J K Knit Composite Ltd. (Extension)

10/1, South Dariapur, Savar, Dhaka-1340,
(23.8348N, 90.2547E)
9th June & 26th August 2021

Buildings Information

Prepared live load plan for 1st and 2nd floor

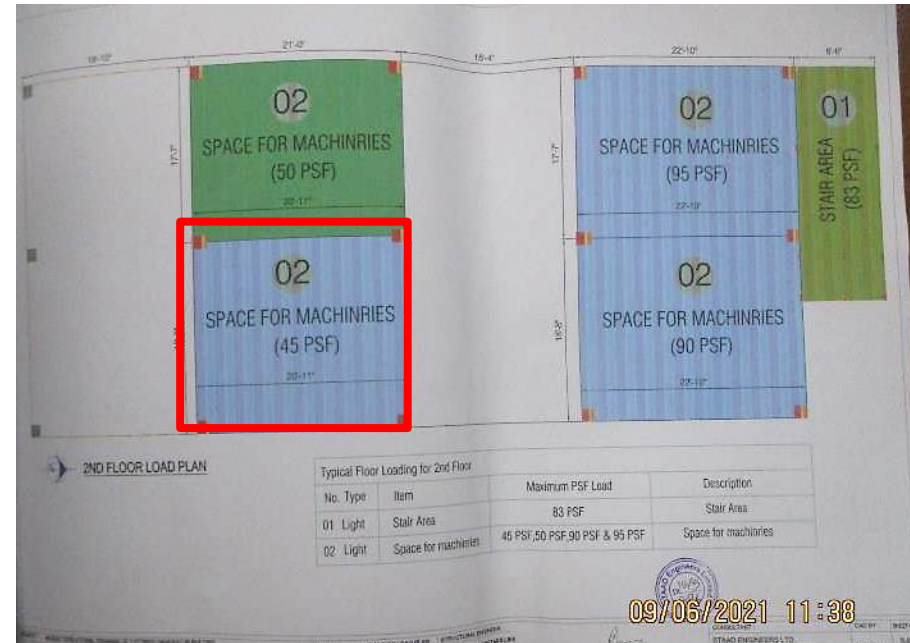
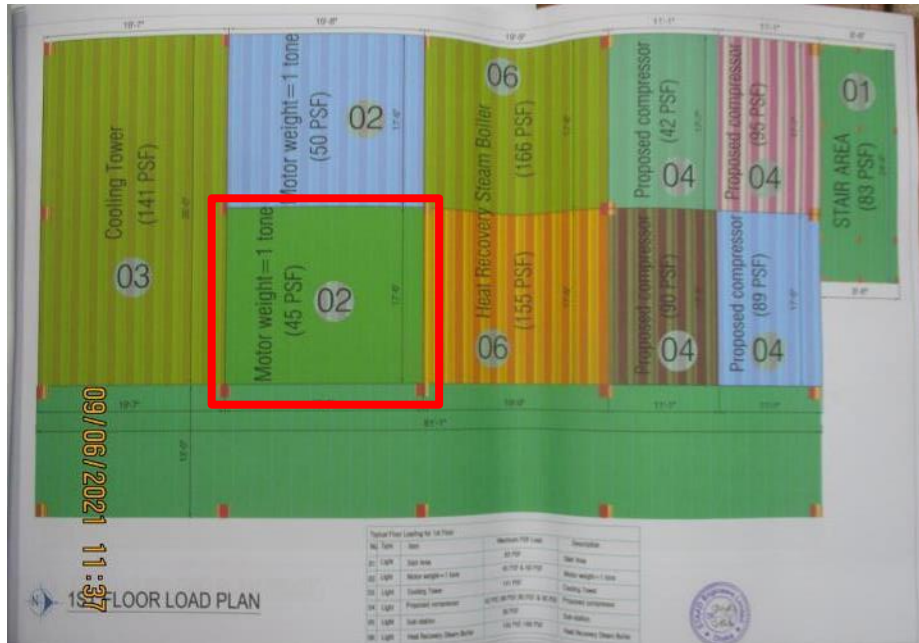
Prepared live load plan need to be revised

The factory engineer prepared a live load plan for 1st and 2nd floor considering 45 psf (2 kPa). As per BNBC requirement, the minimum floor live load for factory building is 3 kPa. So, the factory engineer is required to revise the floor load plan based on minimum live loading requirements of BNBC and column, floor & foundation capacity.

Central column Size: 375 mm x 450 mm

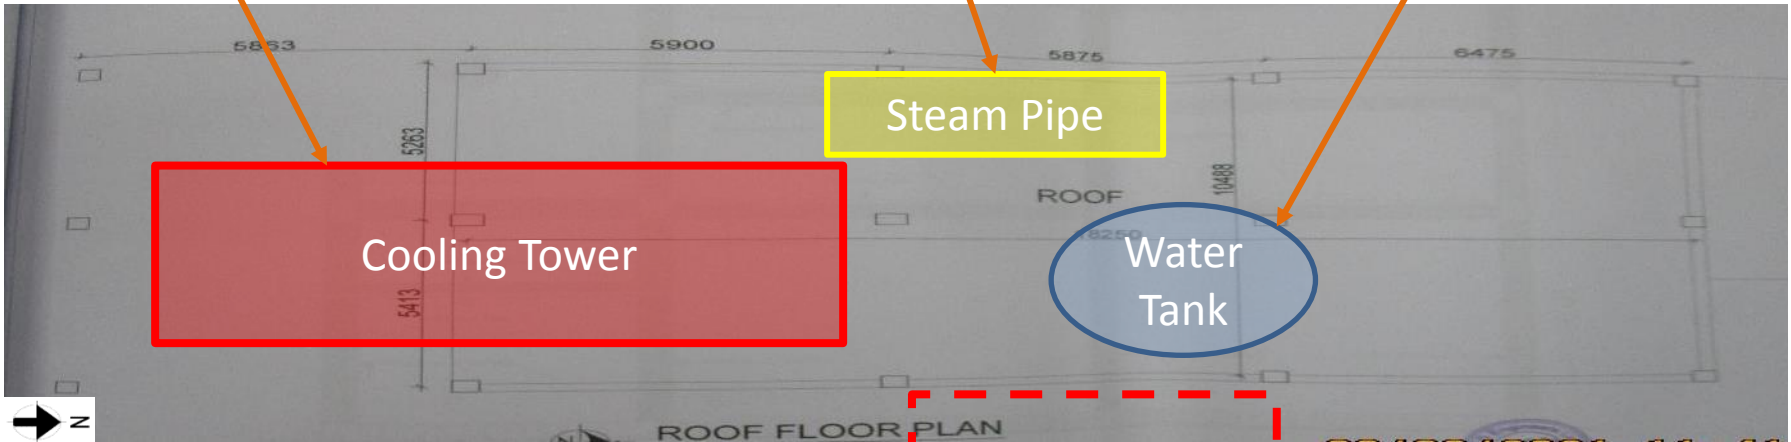
Slenderness effect of column

The ground floor height is 6 m and clear height of column is 5.5 m. The least dimension is 375 mm. There is no intermediate tie beam. The factory engineer is required to check the slenderness effect of the column.

Undocumented horizontal expansion

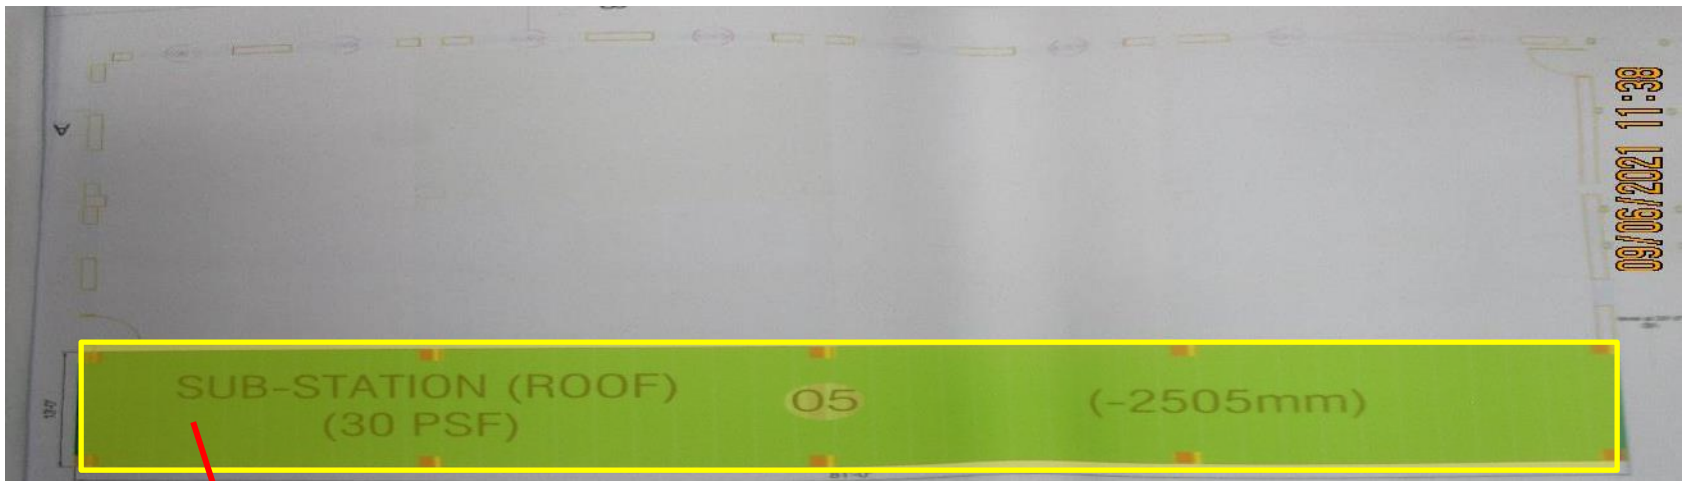
Cooling tower, steam pipe and water tank were not mentioned in the roof layout plan. Undocumented horizontal expansion at east side of the building with steel framing was observed.

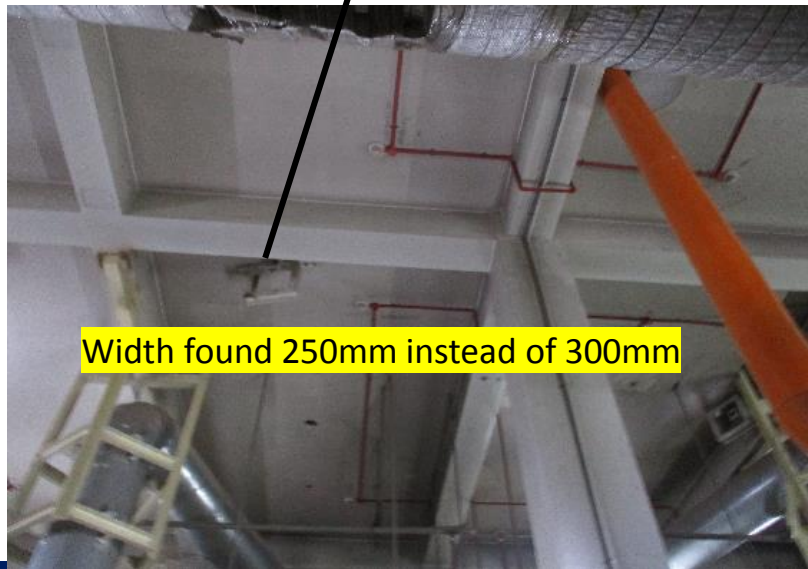
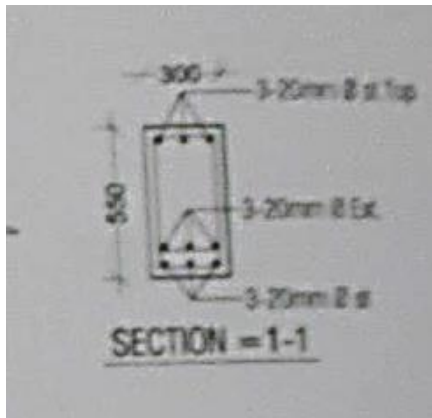
Mezzanine level not mentioned in as-built drawing. Only load plan was found.

Undocumented water reservoir was found on the 1st Floor.

Width found 250mm instead of 300mm

Beam width for ground floor, second floor and staircase does not match with provided drawing.

75mm build up at 1st floor not mentioned.

Concrete core sample location

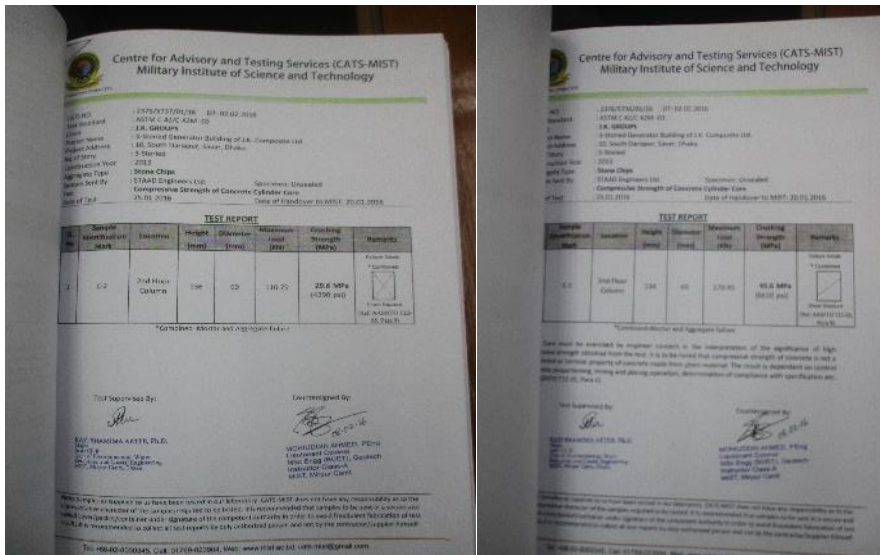
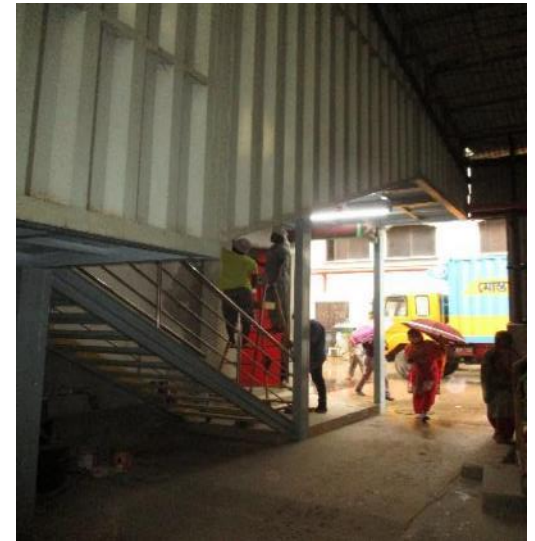
Mismatch of concrete core number

13 number of concrete cores were taken from different locations of beam and column. But we identified only 5 core locations. Core layout plan was not available. Factory engineer to prepare core layout plan properly.

Crack at roof slab and stair beam

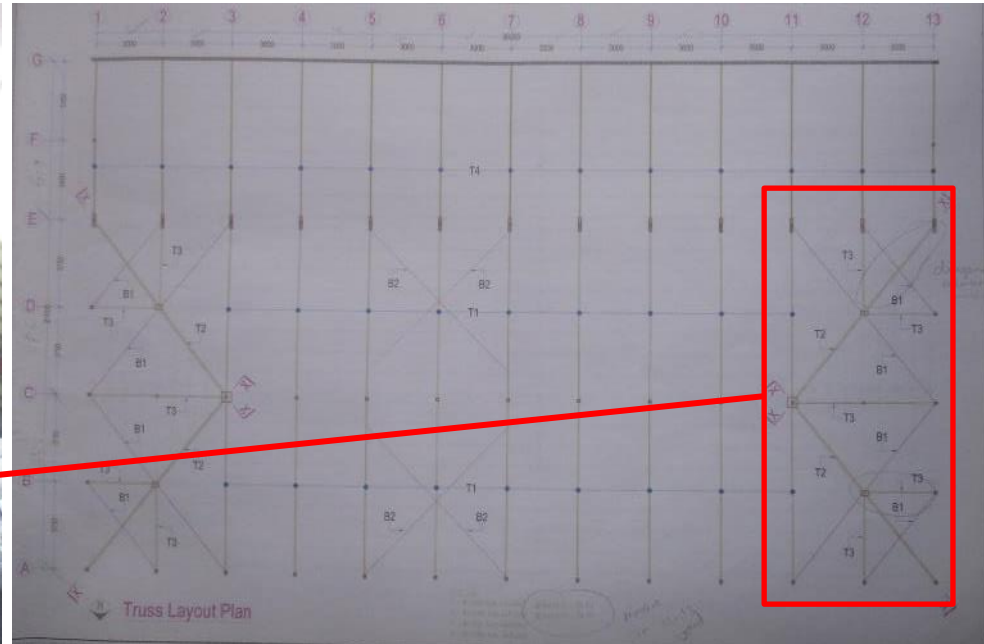
Stagnant water on roof, Hair line crack in slab and beam

Stagnant water found at roof.

Column Layout drawing

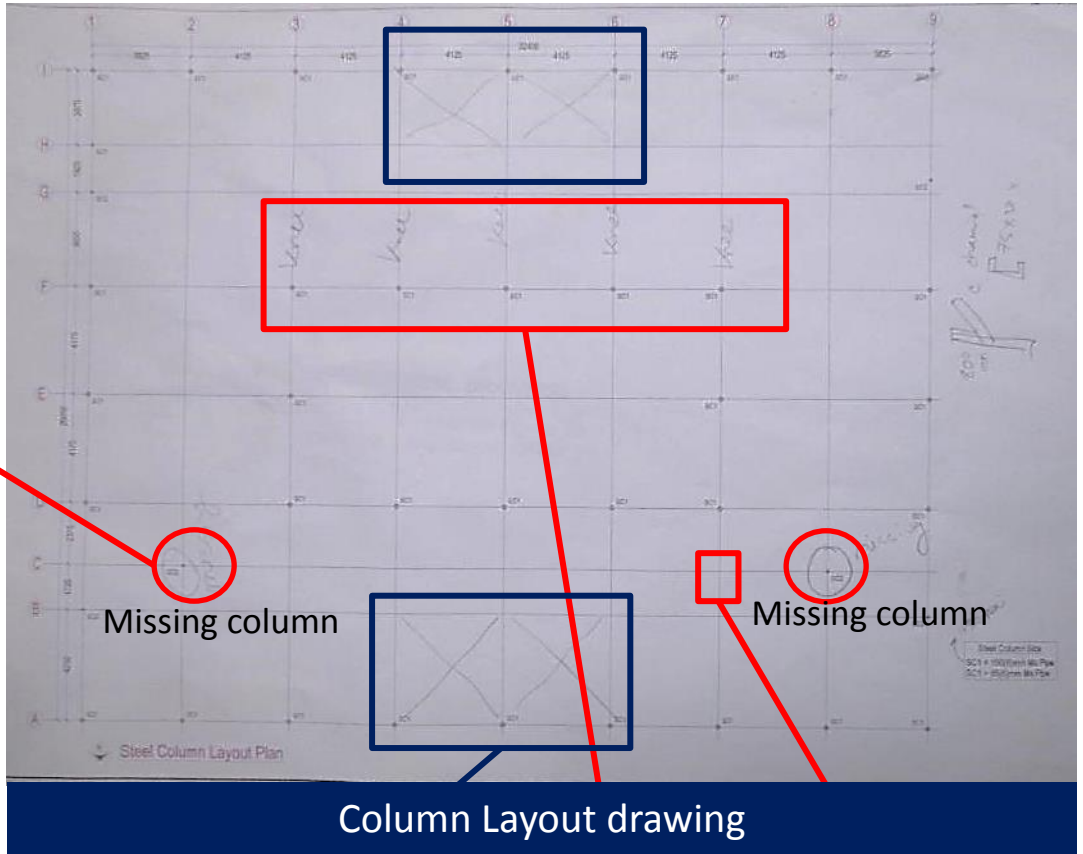
Diagonal truss chord was cut off and roof bracing between grid 11 & 13 was missing.

Steel column missing in marked location.

The factory is required to reinstall the diagonal truss chord. Also, the factory is required to analyze the structure to confirm the bracing requirements.

Architectural drawing.

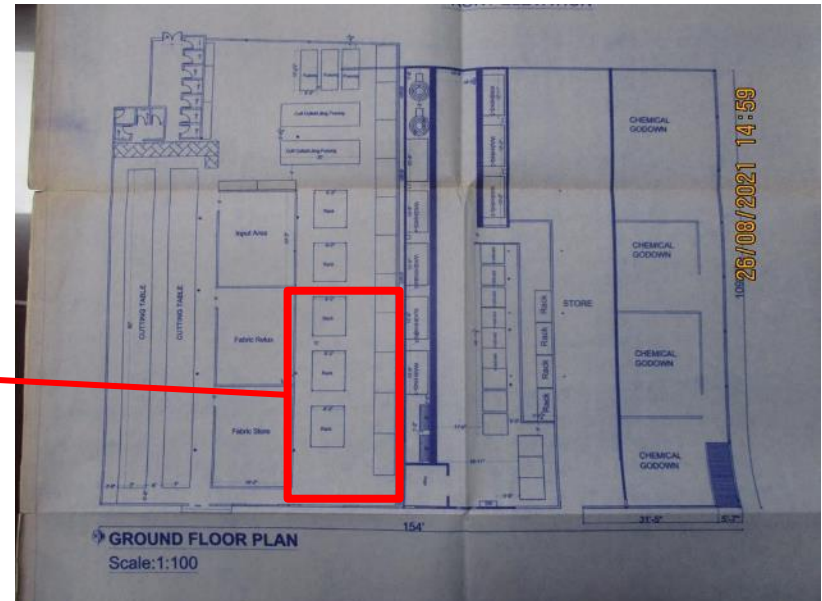
Discontinuous roof bracing.

Undocumented knee bracing.

This portion was not shown in the drawing.

Floor layout shown in the architectural drawings does not match with the as-built conditions. Factory engineer to survey the structure and update the as-built drawings and review the design accordingly.

Truss and Footing Layout Plan.

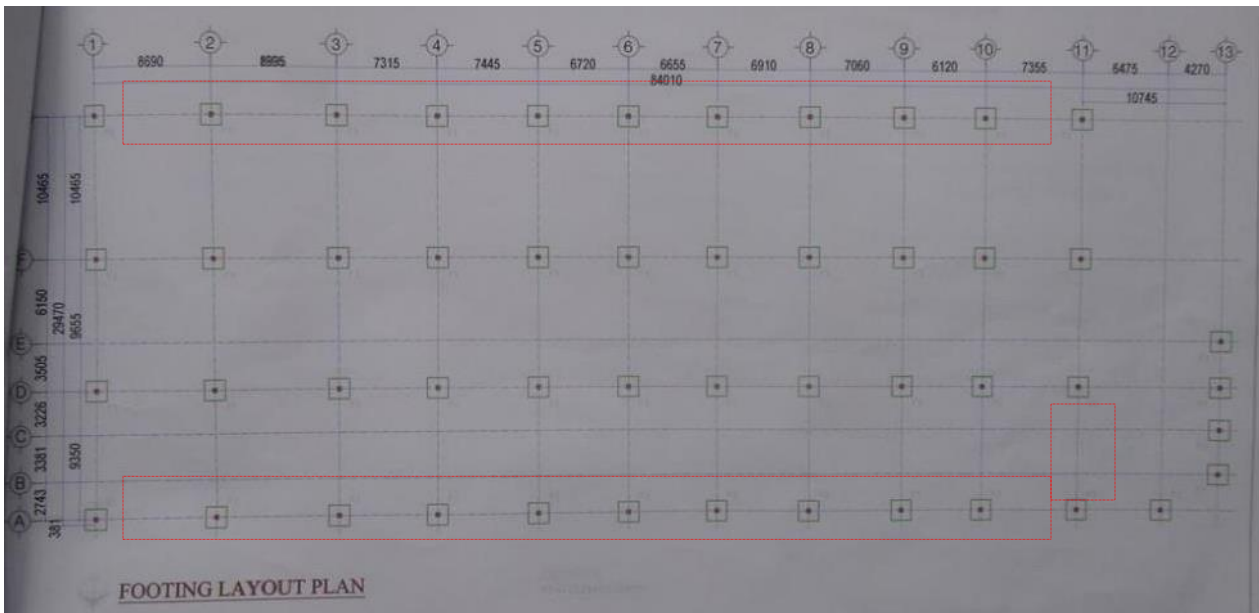
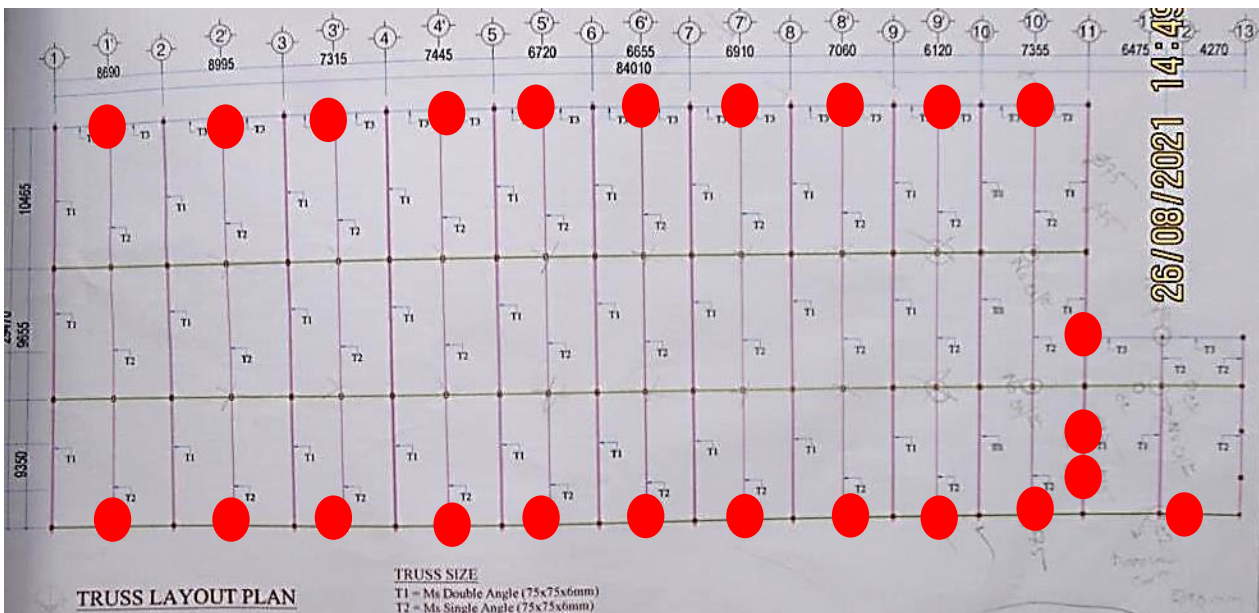
Pipe column without foundation details

There are some steel pipe columns marked in the layout. The steel pipe columns along periphery and below the secondary trusses have no foundation details.

The factory engineer to update the as-built drawings and check the adequacy of the pipe columns for gravity and lateral loads, also provide necessary alternatives for the foundation of columns.

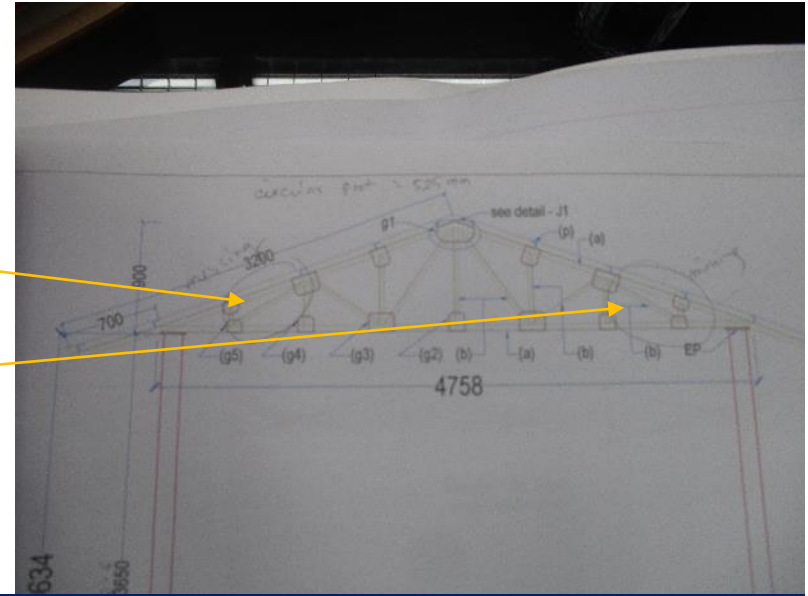
Discrepancies in as-built drawings

Missing vertical member

Top & Bottom Chord and bracing thickness 5mm instead 6mm

Purlin number found 10 instead 12 and section 38X38X5 instead 50x50x6
